APEX PLAZA CONDOMINIUMS

CONCEPTUAL MULTI-USE BUILDING

From: Terryne Bergeson
Sent: Tuesday, November 19, 2024 12:44 PM
To: Dayana Ludlow
Cc: Miguel; preston Croxford
Subject: File Review #7C24 & 2S24 - Apex Plaza Condominiums Conditional Use Site Plan and Subdivision
Attachments: TBID COMMENTS.pdf

This transmittal contains review comments related to the plans and documents for the conditional use site plan review and subdivision for the property at 4255 S. Redwood Rd. Please review the comments and revise plans accordingly. The Taylorsville Bennion Improvement District comments will require some changes to the plans.

CU300

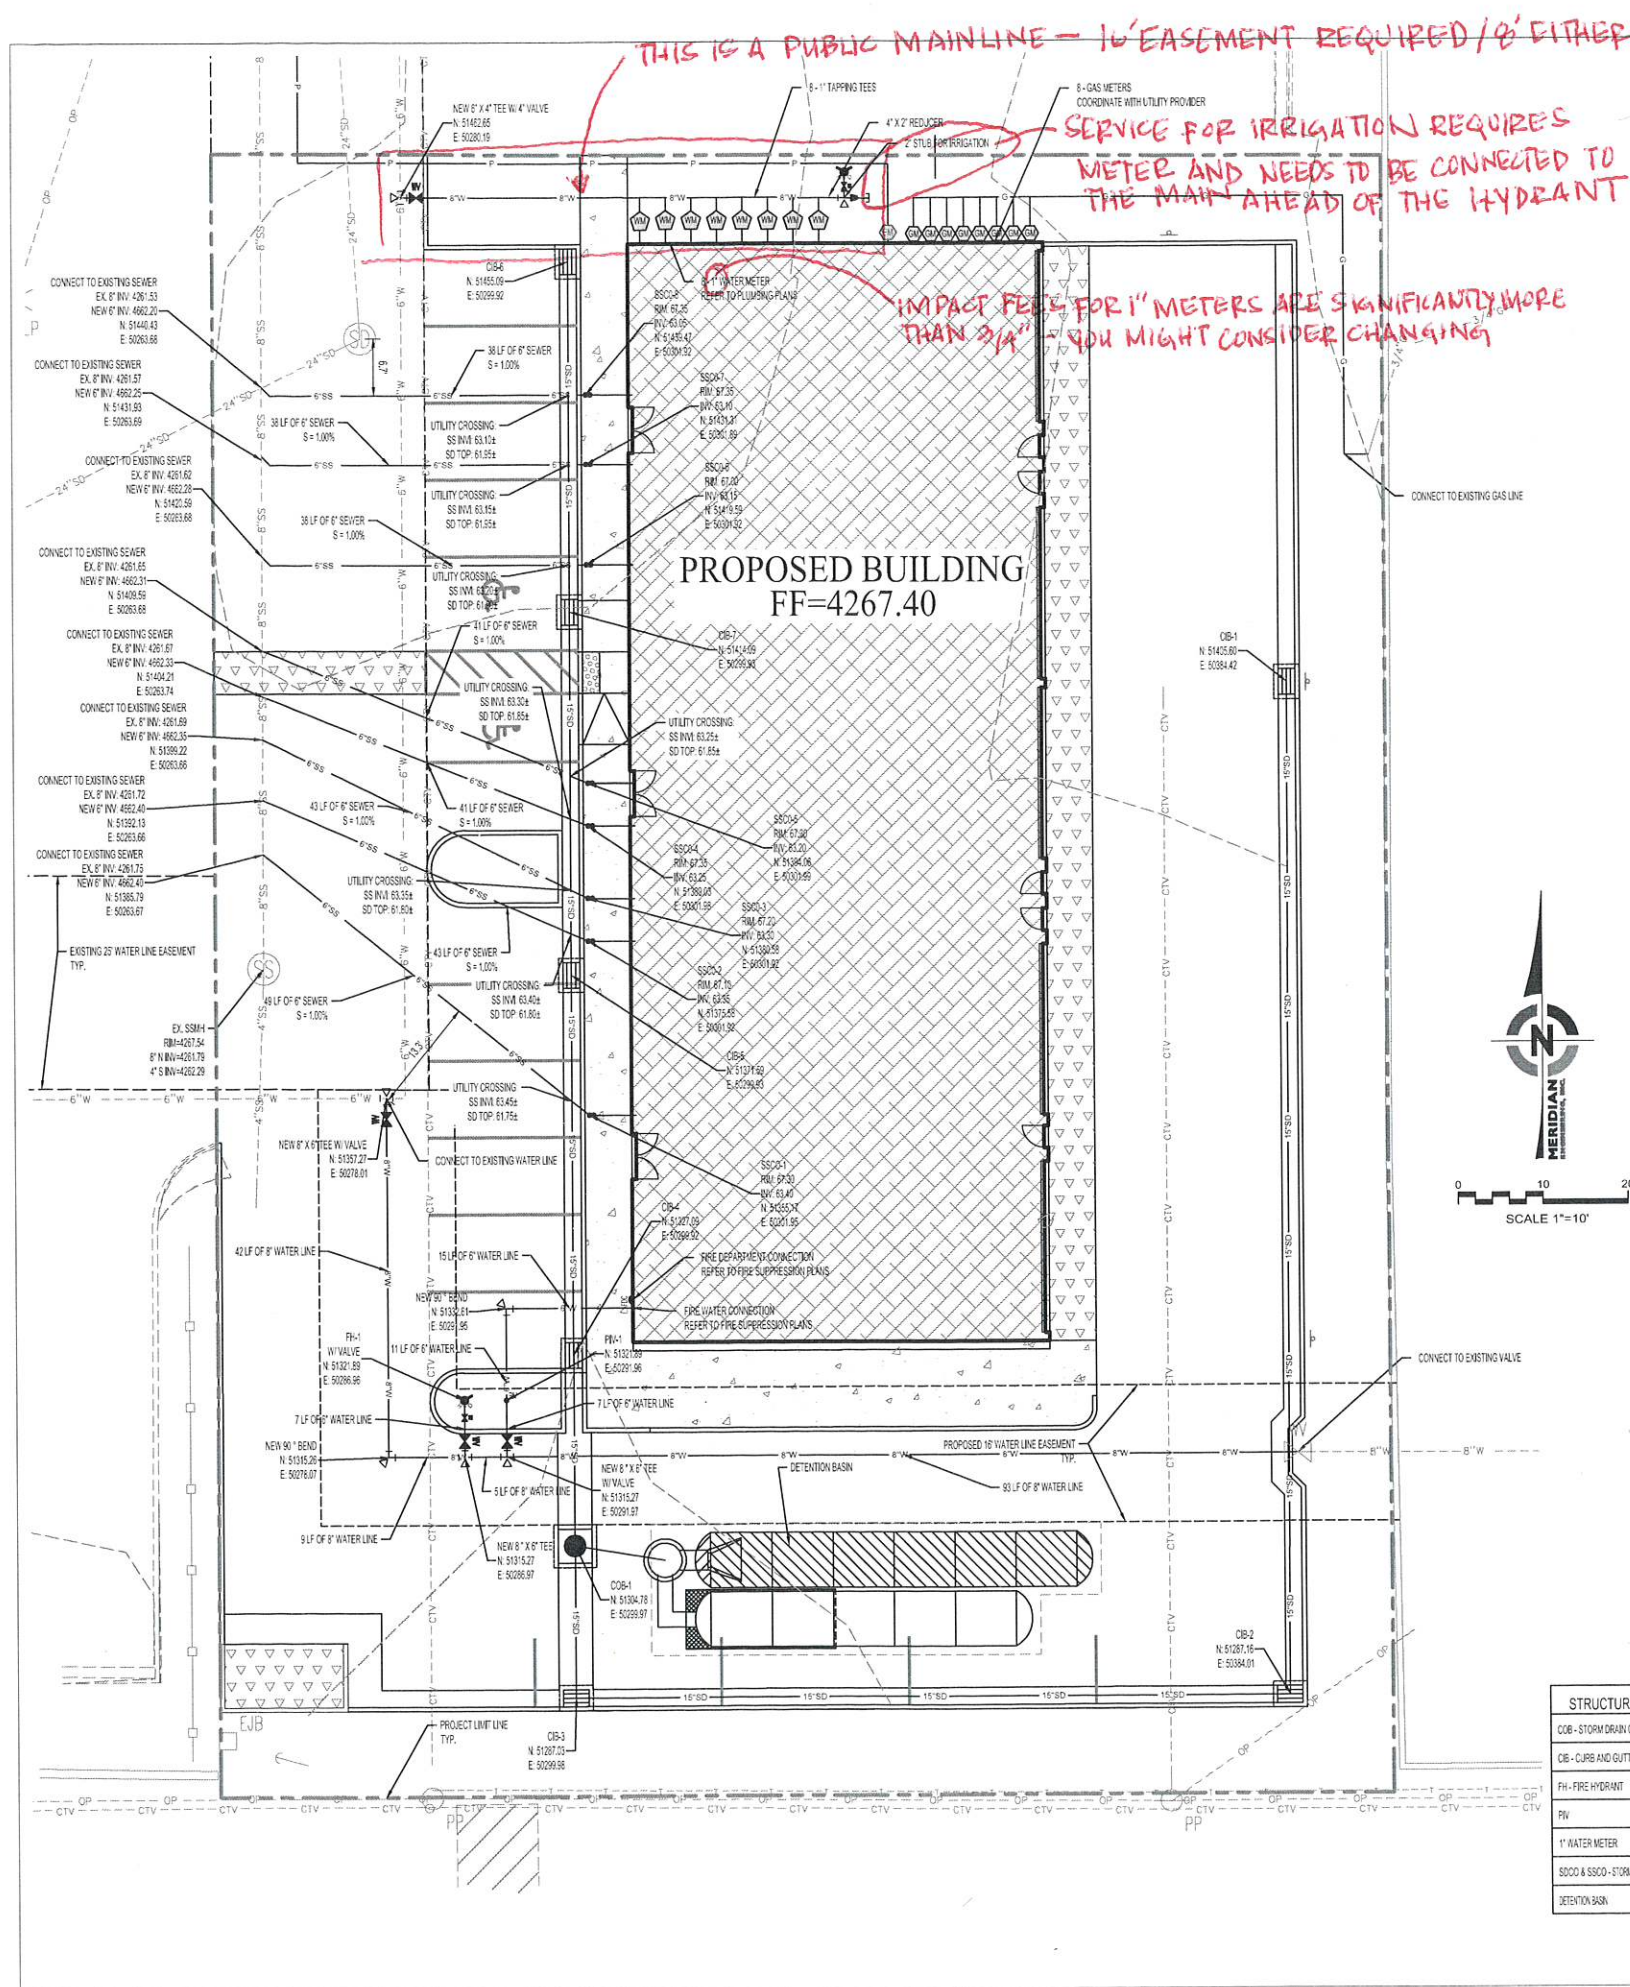
3. The 8" line to the north of the building that has all of the water services off of it, is a public water line owned by the District. An easement is required to own and maintain that line. The easement shall be 16' wide, 8' either side of the centerline.

4. The water service for the irrigation stub is required to be metered and will need to be connected ahead of the hydrant
5. Impact fees for 1" meter connections are significantly higher than ¾" services. Owners usually choose to go with ¾" for a typical residential unit. I recommend reviewing the needed demands and considering the smaller meter to save money.

7. Mechanical restraints are required at all fittings in addition to thrust blocks.
8. There is some discrepancy between the plans and the notes outlining the size and material of piping.

9. Sewer and water mains are public- whether in the ROW or not. If not located in a public ROW, easements are required to maintain the lines.
10. Waterlines shall be buried with 3.5' of cover.

11. There is some conflicting data between notes. See redline plans.

- SITE CONTRACTOR SHALL COORDINATE WITH TAYLORSVILLE BENEFIT IMPROVEMENT DISTRICT WHEN COMPLETING THE SEWER CONNECTION. **DISTRICT MAKES WATER CONNECTIONS FOR SERVICES 3/4\"/>**

- SITE CONTRACTOR SHALL COORDINATE WITH TAYLORSVILLE BENEFIT IMPROVEMENT DISTRICT INSPECTOR WHEN COMPLETING WATER CONNECTIONS IN CITY STREETS OR ON SITE WHERE REQUIRED. **THURST BLOCKING & RESTRAINTS @ FITTINGS REQUIRED**

- REFER TO SHEET C200 FOR PROJECT BASIS OF BEARING, BASIS OF COORDINATES AND BENCHMARK.
 - ALL UTILITIES OUTSIDE OF PUBLIC R.O.W. ARE PRIVATELY OWNED AND SHALL BE MAINTAINED BY OWNER UNLESS NOTED OTHERWISE. **NO! SEWER & WATER MAINS PUBLIC EASEMENTS REQUIRED**
